***ADDENDUM REPORT:***

***MAJOR PROJECT ASSESSMENT  
Russell Vale Colliery Underground  
Expansion Project (MP 09\_0013)***

Section 75I of the  
*Environmental Planning and Assessment Act 1979*  
November 2015

CULVERT LAYOUT PLAN  
SCALE 1:250

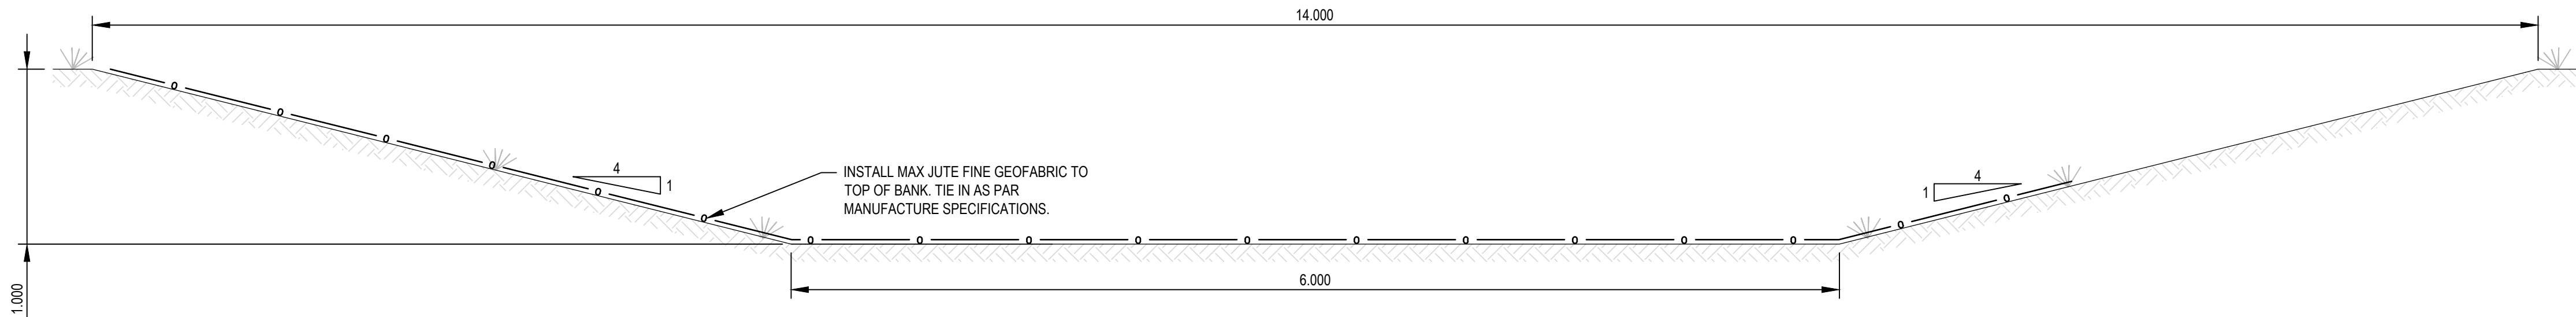
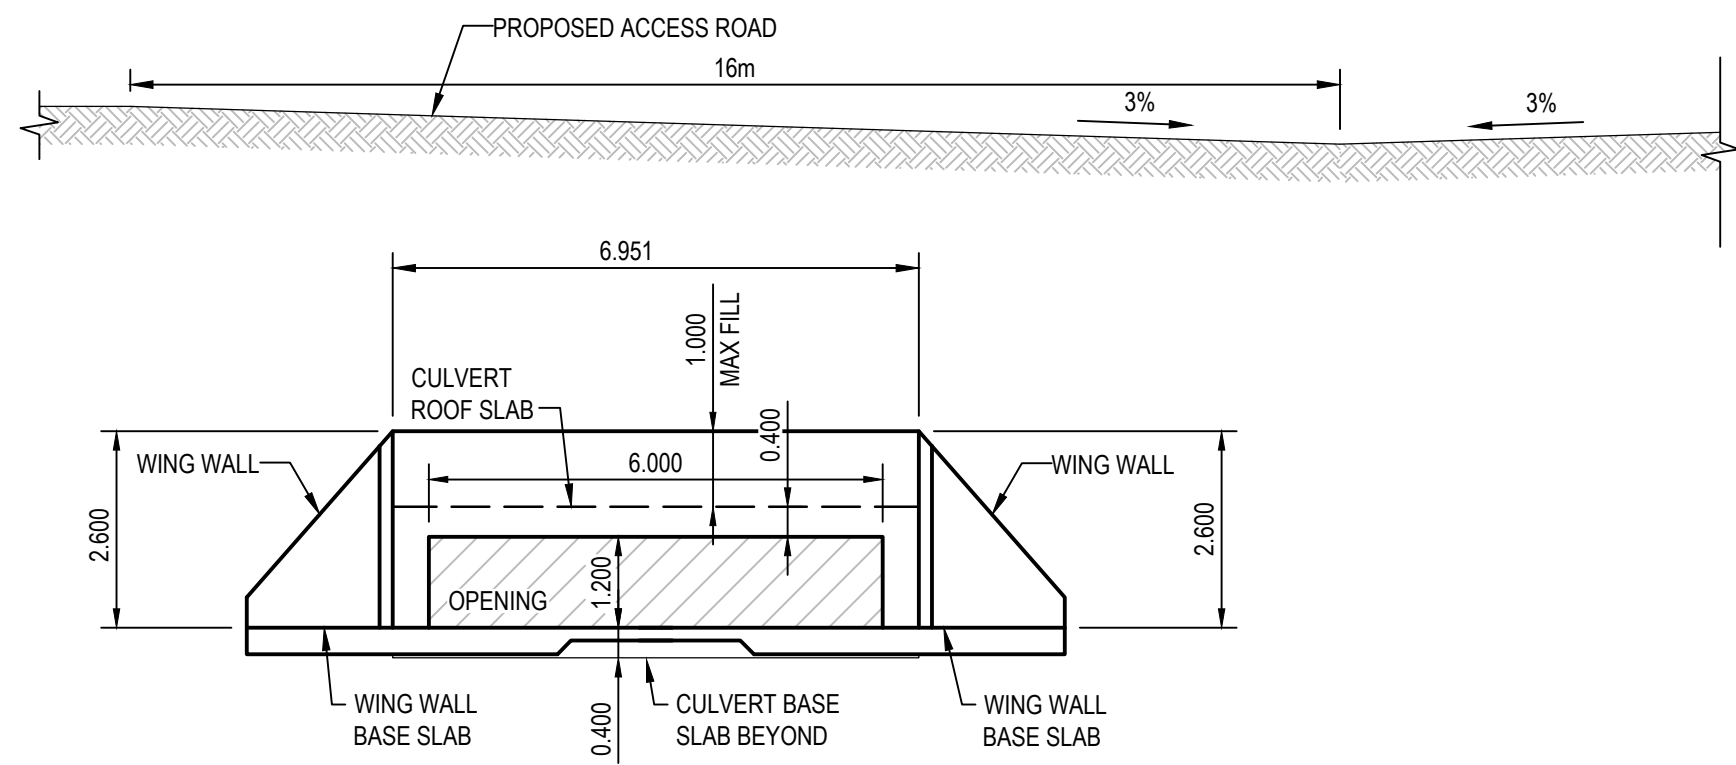
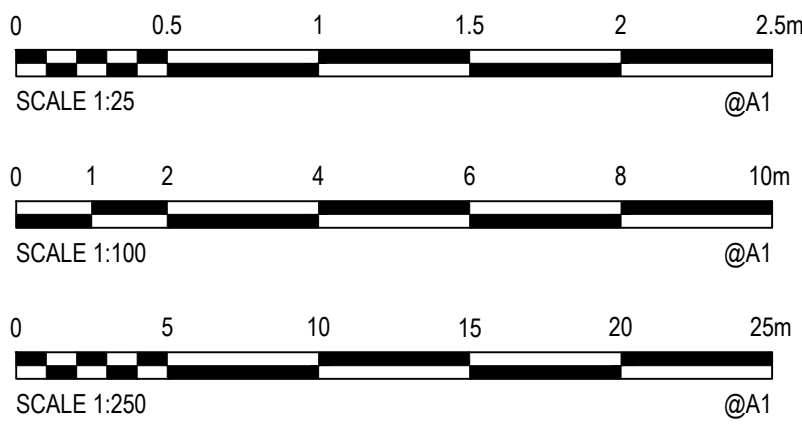
Rev.	Date	Description	Des.	Verif.	Appd.
2	7/01/2015	MINOR AMENDMENTS AS PER COUNCIL COMMENTS	BAH	SBR	ODJ
1	24/11/2014	ISSUED FOR APPROVAL	AMW	SBR	ODJ
